**Development Review Board
Panel A Meeting
May 10, 2021
6:30 pm**

- V. Consent Agenda:
 - A. Approval of minutes of the April 12, 2021 DRB Panel A meeting
 - VI. Public Hearings:
 - A. **Resolution No. 388 (*revised*). Canyon Creek ~~8-Lot~~ 5-Lot Subdivision: Scott Miller, SAMM-Miller LLC – Applicant for William Z. Spring and Fallbrook, LLC – Owners.** The applicant is requesting approval of a Comprehensive Plan Map Amendment from Residential 0-1 Dwelling Units per Acre to Residential 4-5 Dwelling Units per Acre, a Zone Map Amendment from Residential Agriculture-Holding (RA-H) to Planned Development Residential 3 (PDR-3) and adopting findings and conditions approving a Stage I Master Plan, Stage II Final Plan, Site Design Review, Type C Tree Plan, Tentative Subdivision Plat, ~~and Waiver for an 8-lot~~ 5-lot residential subdivision located at 28700 ~~and 28705~~ SW Canyon Creek Road South. The subject site is located on Tax Lot 6400 ~~and a portion of Tax Lot 3800~~ of Section 13BD, Township 3 South, Range 1 West, Willamette Meridian, City of Wilsonville, Clackamas County, Oregon. Staff: Philip Bradford

**Development Review Board – Panel A
Minutes– April 12, 2021 6:30 PM**

Previous Usable Open Space Location (Tract A)

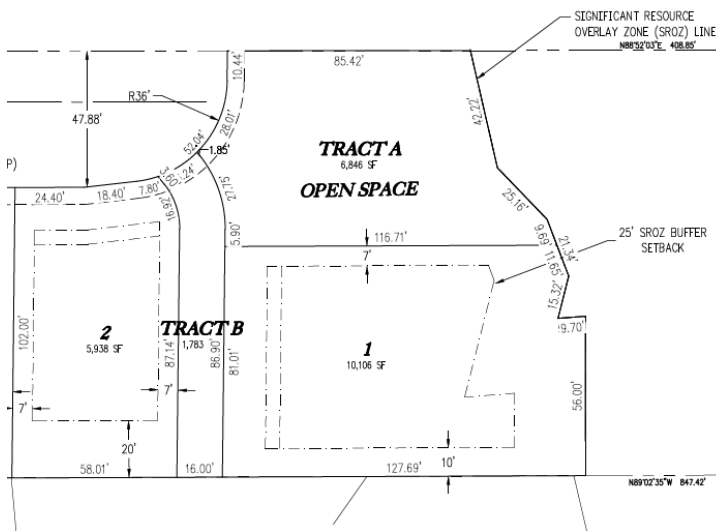
On April 29, 2021 the applicant sent staff a revised subdivision plan that includes a newly configured open space area (Tract A) which now provides 6,729 square feet of usable open space. The location of the open space is more appropriate than the previous proposal and allows clear sightlines into the usable open space area and adjacent natural area. Due to the time constraints involved in revising the open space to meet the requirement that it be designed by a registered landscape architect, the open space has been conditioned to return to the DRB for final design approval.

<p>PDD 14. <u>Prior to Final Plat Approval:</u> The applicant shall submit a revised Sheet L1 showing the landscaping plan to match the new shape and square footage of the proposed usable open space area in Tract A. <i><u>If the project landscape architect changes, the applicant shall submit a new Affidavit of Professional Credentials for Residential Usable Open Space Areas in the City of Wilsonville. For final approval of the revised open space area, the applicant shall return to the Development Review Board for review of the redesigned open space.</u></i> See Finding D49.</p>
<p>PDD 15. <u>Prior to Final Plat Approval:</u> The applicant shall revise the CC&R's and Bylaws documents to require the future Homeowners Association to actively enforce no parking areas, tow any illegally parked vehicle within 12 hours, and establish fees for homeowners who violate the no parking zones. See finding D37.</p>

FIGURE 3-9. LOCAL STREET CROSS-SECTION

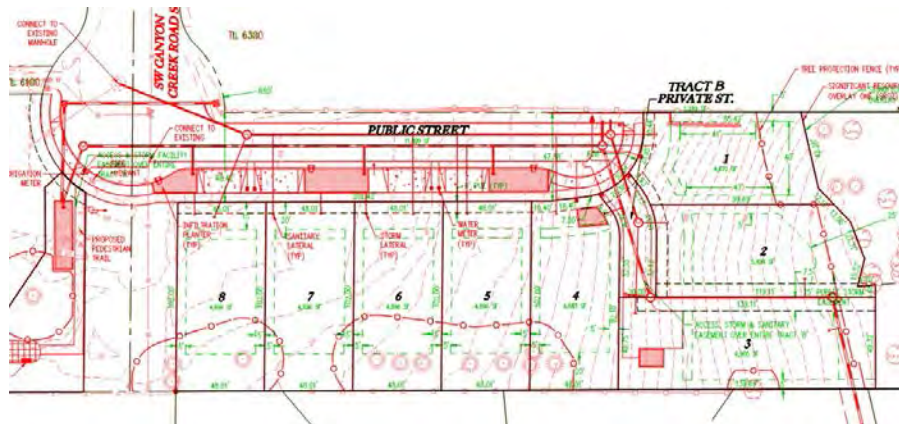
- Multiple drawings had been submitted showing street width of 47-ft, but digging deeper, Drawing 8 depicted a curb-to-curb dimension of 24-ft, but in Figure 3-9, the Code requirement was a minimum of 28 ft to 32 ft.

D54. The City Engineering Division has preliminarily found the street designs and widths as consistent with the cross sections shown in Figure 3-9 of the 2013 Transportation Systems Plan. The Engineering Division will check final conformance with the cross sections shown in the Transportation Systems Plan during review of the Public Works Permit.

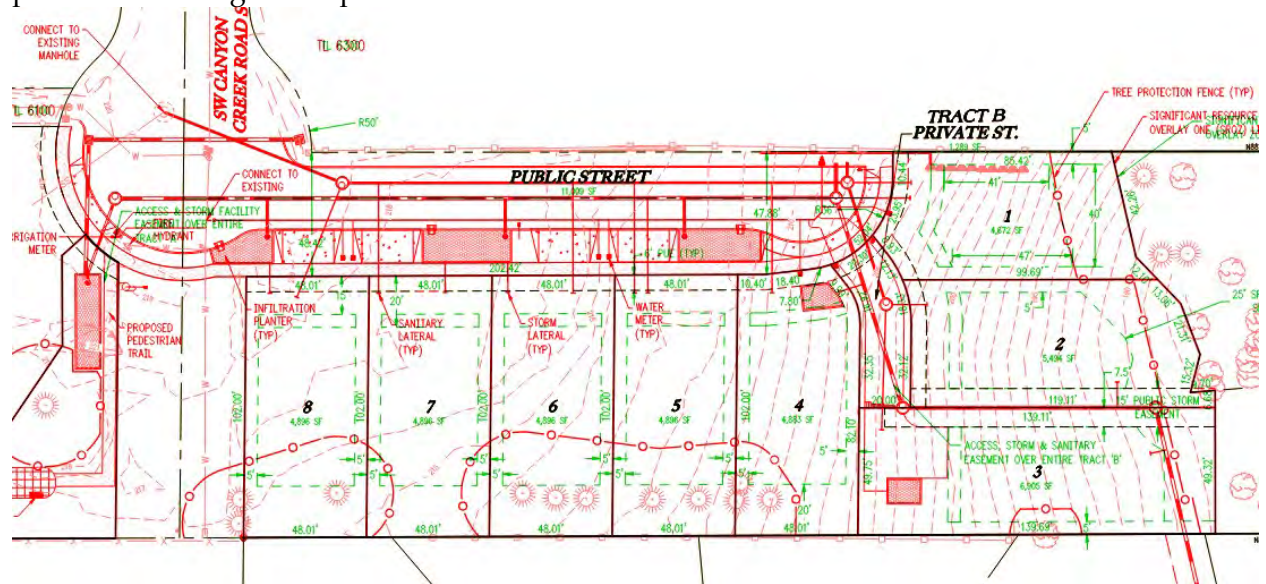
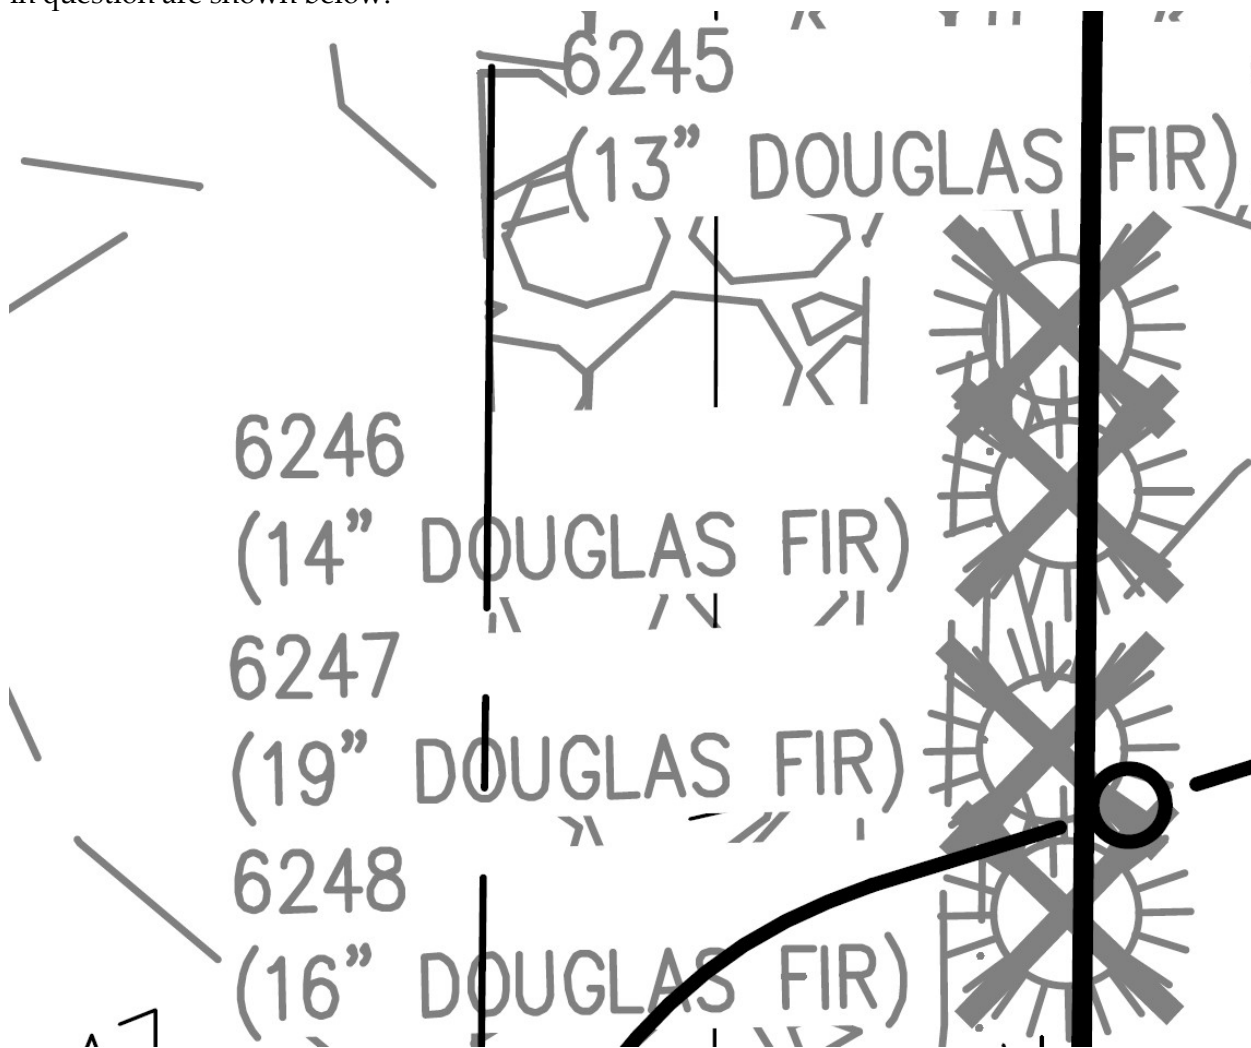
Staff questioned the applicant on the proposed tree preservation plans as they relate to the construction of future homes on the newly created lots. The applicant’s response contained in Exhibit B5 states: *“The submitted tree preservation and removal plan is specific to the construction of the subdivision only and does not include potential tree removal to accommodate the future homes. Any necessary tree removal required for lots 4-6 and 7 to accommodate future dwellings will be addressed during the building permit review process.”*

In addition to the issues concerning the trees at the rear of lots 2-5 4-8, the trees proposed for removal along the western property line of Lot 8 appear to be on City of Wilsonville property and the applicant does not have City permission to remove these trees. The trees in question are shown below:

Condition of approval PDF 8 requires Tree Numbers 6245 (13" Douglas Fir), 6246 (14" Douglas Fir), 6247 (19" Douglas Fir), and 6248 (16" Douglas Fir) shall be retained unless City approval and signature is granted for these four (4) trees. The applicant shall revise the tree protection fencing plan to ensure these trees are properly protected during grading and construction. Should these trees require removal in the future due to construction, the applicant shall provide an assessment from an arborist as outlined in Condition of Approval PDF 9, and may be removed if City Staff and an independent arborist concur that removal is necessary.
